PRODUCT CHANGE NOTIFICATION

Product hierarchy no. *				Part no.	SBU	Type / Description	Customer part no.
SBU	PG	PGU	Type				
02	006	016	0000001600	5145.XXXX	Power Entry Module with Filter	5145

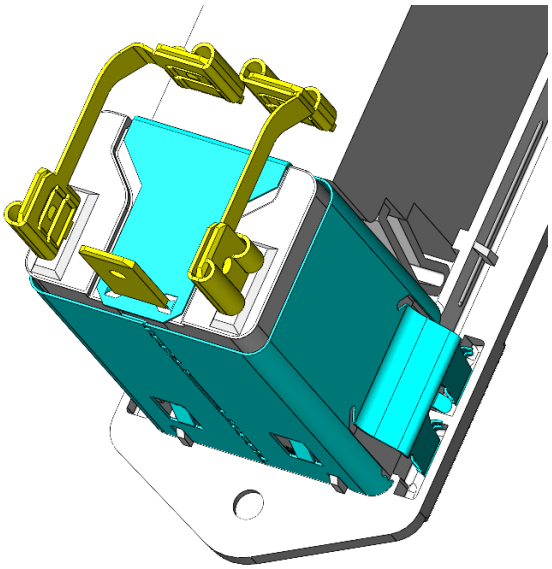
a) Soldered wire connection between filter and circuit breaker replaced by faston connection.

Old version:

New version:

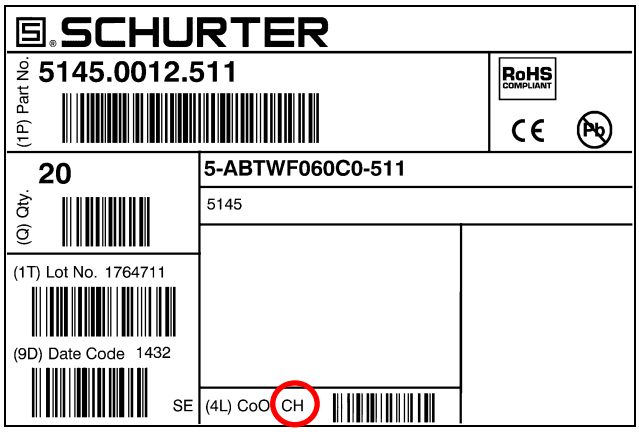
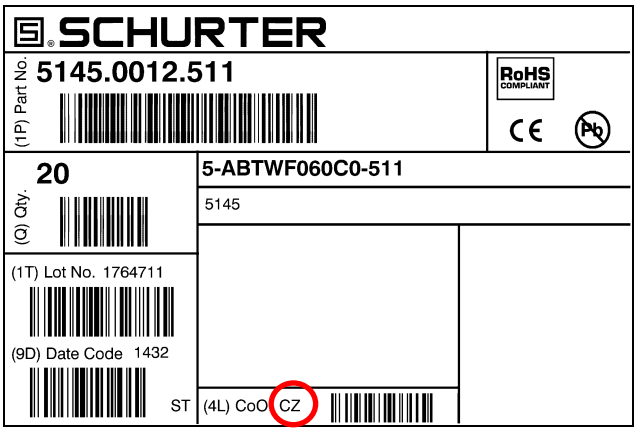
b) Production relocation from Switzerland to Czech Republic.
New Country of Origin (CoO).

Old packing label:

New packing label:
